## **Response to Trustee Questions - Supplemental Analysis of Stormwater Options**

This document presents responses to questions regarding the Village's plan for stormwater improvements west of Ridge Road as posed by Village Trustees during the Summer of 2017.

Prepared for:  
Village of Wilmette  
1200 Wilmette Avenue  
Wilmette, Illinois 60091

Prepared by:  
Stantec Consulting Services, Inc.  
350 N. Orleans Street, Suite 1301  
Chicago, Illinois 60654

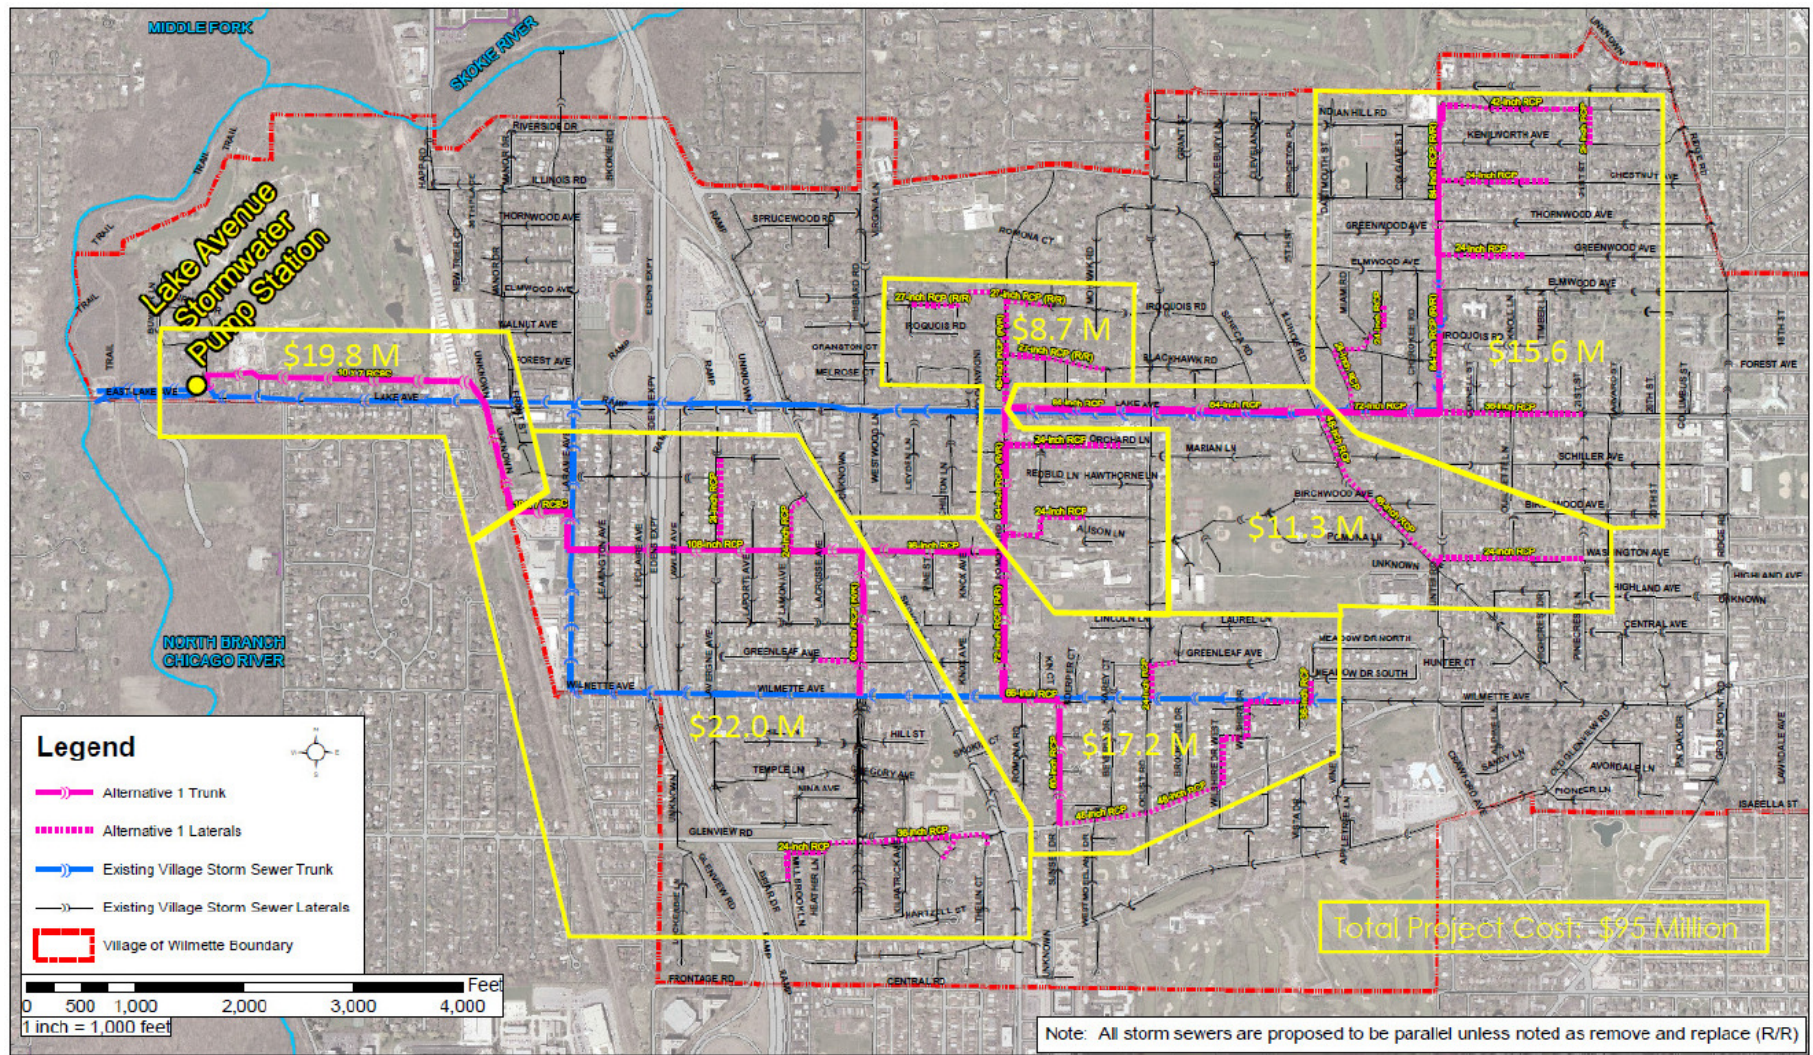
The attached Figure 1 provides a generalized estimate of construction costs for segments of the CBBEL Alternative 1 Relief Sewer Project. The values shown for the individual segments of the project reflect the approximate total project cost for improvements within each area. Since this analysis does not account for the relative cost of capacity in downstream segments required to serve upstream areas, the values presented likely overestimate the portion of the project cost assigned to segments of the project close to the Stormwater Pump Station and

However, a subsequent analysis did show that there is some variation in the relative cost for the conveyance improvements needed to implement the CBBEL Alternative 1. As noted above in the response to Question 7, the attached Figure 1 and plots on Slide 20 show that the incremental cost to extend the Relief Sewer Option (CBBEL Alternative 1) increases as areas farther from the Stormwater Pump Station are served. These results led to the development of two Reduced Relief Sewer Alternatives (one combined with a neighborhood storage element) intended to focus on providing service to areas most cost-effectively (See Slides 16 and 18 for alternative layouts, and Slides 25-28 for alternative comparisons)
